ARCHITECTURAL REVIEW BOARD WORK SESSION AGENDA

Agenda Item: Architectural Review for DP#25-01, 535 Herndon Parkway

Subject: Architectural Review for DP #25-01, 535 Herndon Parkway

Subject: Discussion Item, proposed Special Exception (SE#25-02), 250 Spring Street

RENDERINGS - SIDE BY SIDE COMPARISON

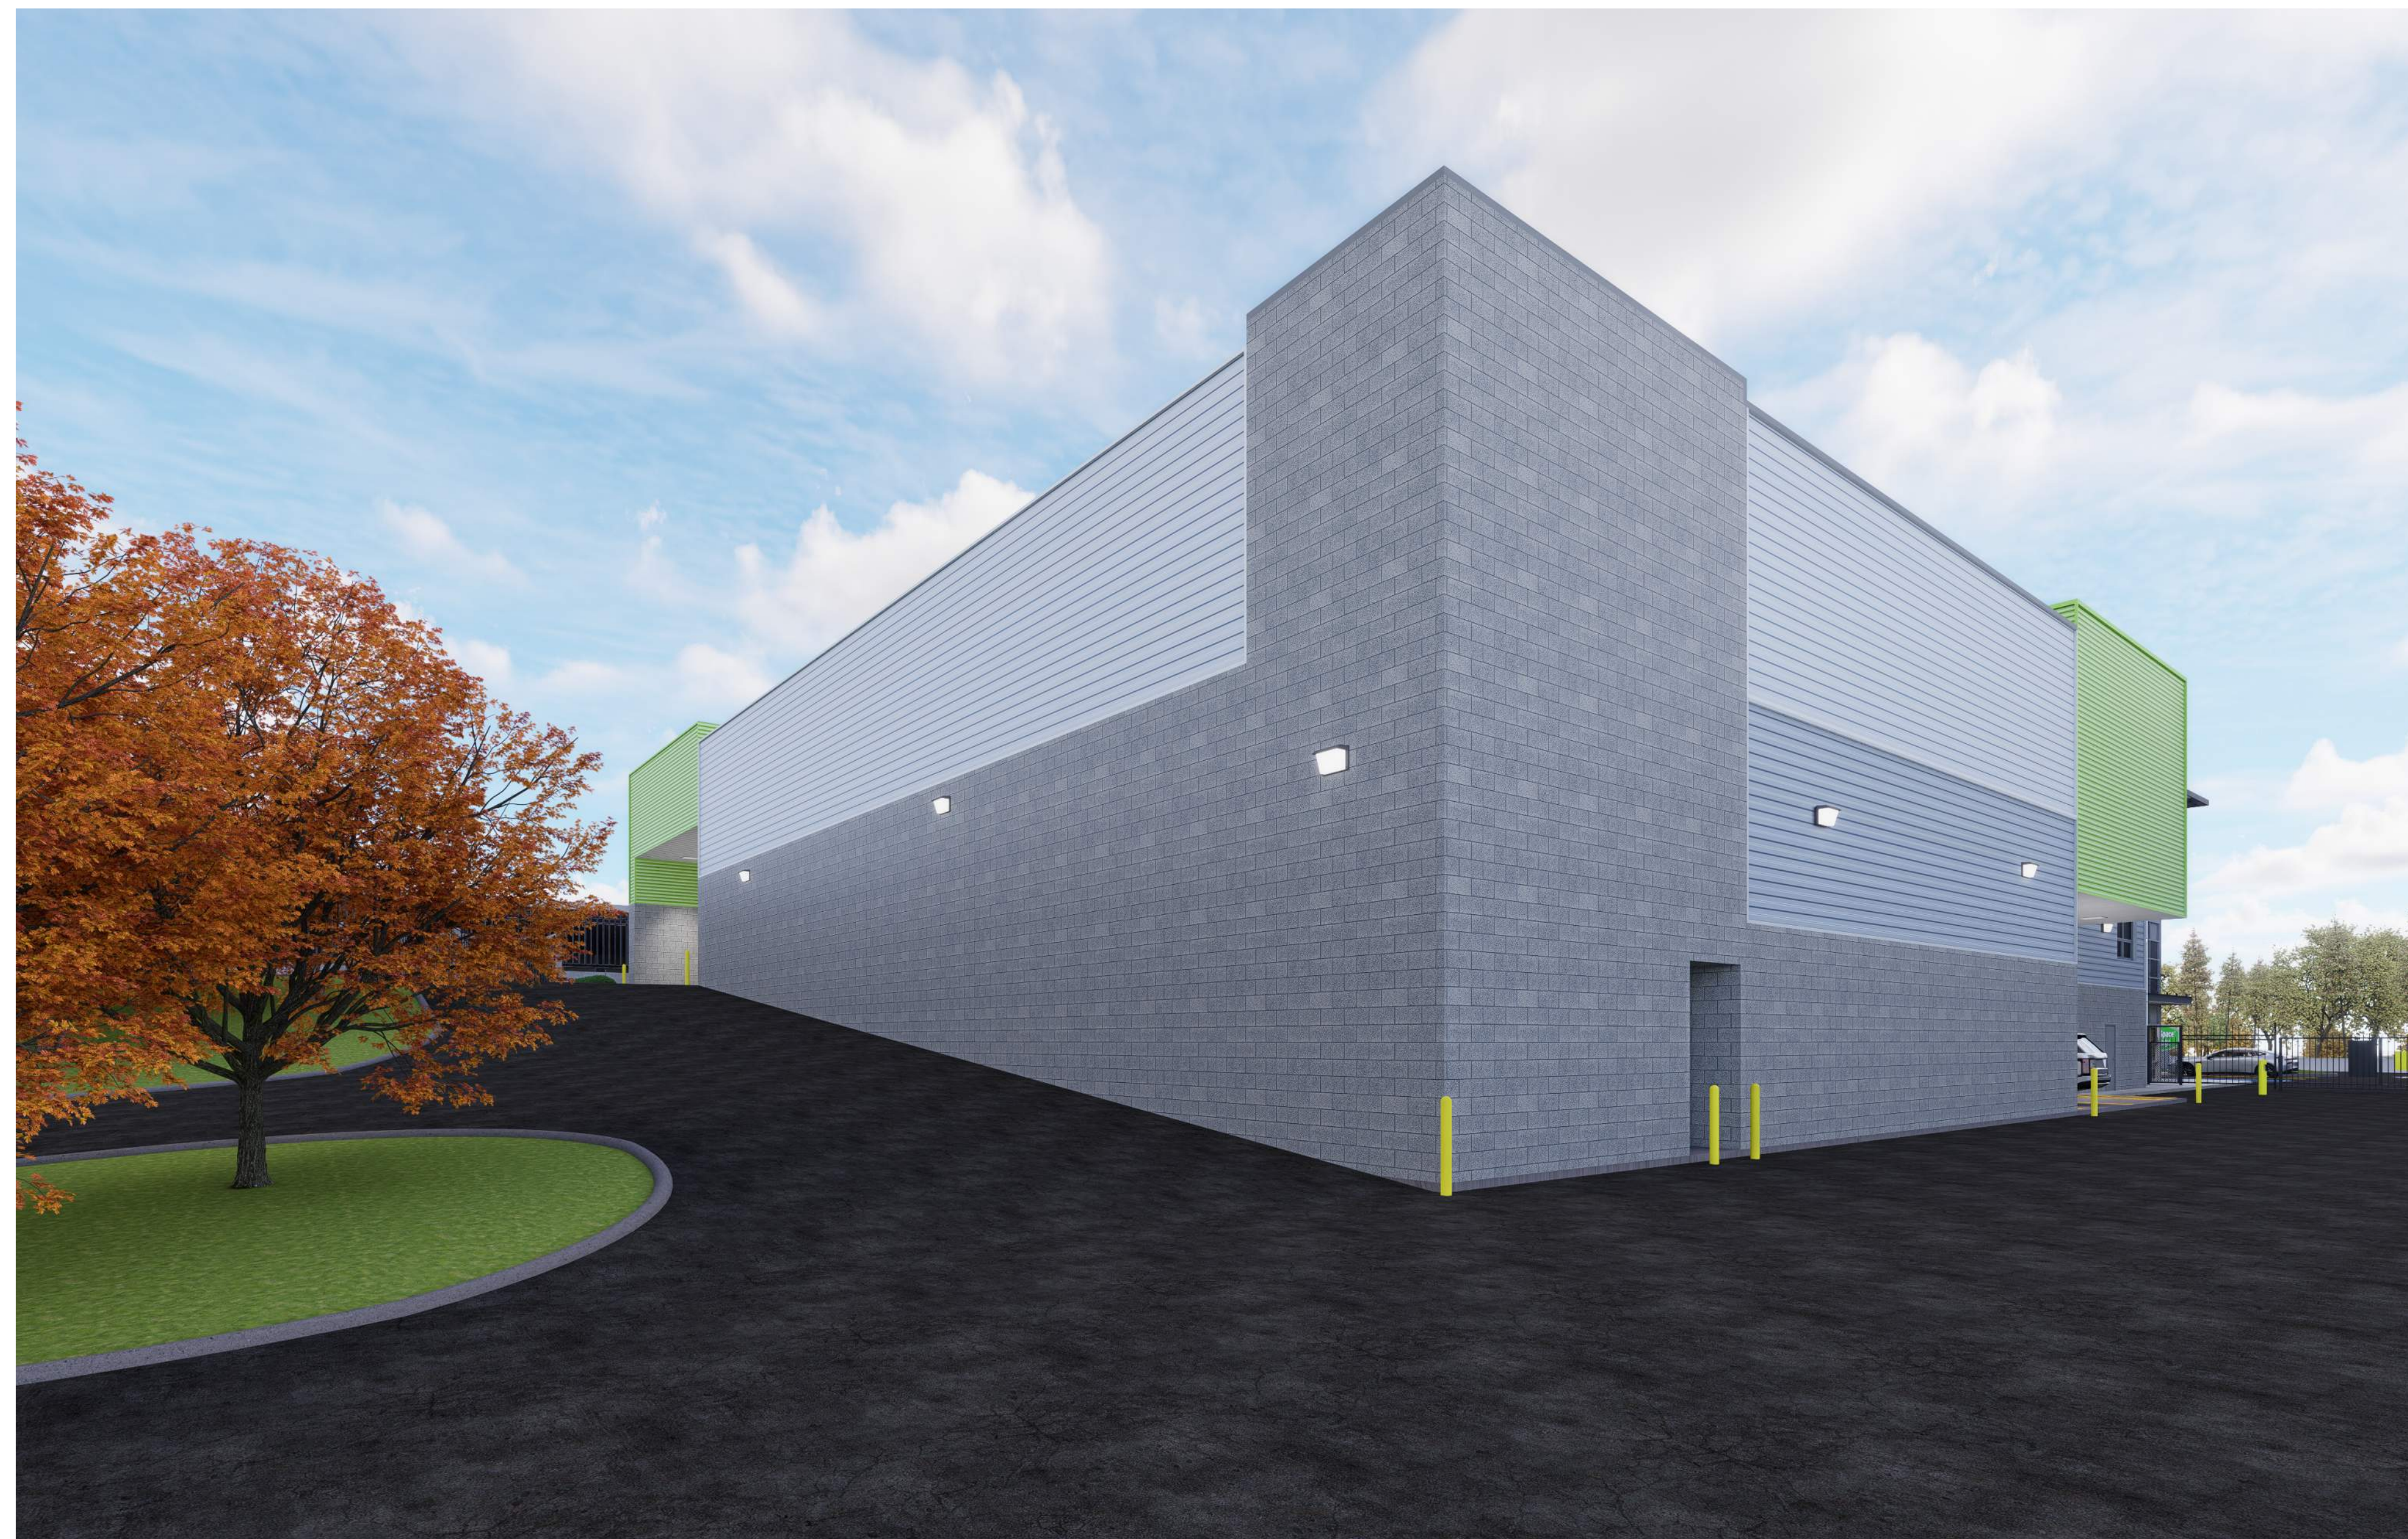
Architectural and Aesthetic Acceptability (Criterion 6): ACD Criterion 6 is partly concerned with whether or not a proposed design for a commercial building could be construed as an advertisement or a commercial display. The design as proposed refrains from using a color palette that is associated with the brand identity of ExtraSpace Storage, although gray is included in some of the masonry and metal siding detailing and the green of the interior will be partially visible from outside the building. Staff is of the opinion that these details are balanced with the prominent use of red brick and off-white siding on all elevations. The previous design proposal for this property submitted as part of the associated Special Exception employed the branded identity of ExtraSpace Storage to a greater extent than the current design (*Figure 6*; sheets A401-A404 of the April 1 meeting materials). The ARB should discuss whether the updated

design sufficiently balances harmony with the architectural character of the surrounding area with elements related to the use of property by a specific corporate entity. Additionally, the use of large swaths of unadorned walls, though largely reflective of the building function, should be assessed for appropriateness and whether additional fenestration or decorative treatments should be employed to add visual interest, manage the scale, and more consistently carry through lines and patterns across the various divergent designs bay-to-bay.
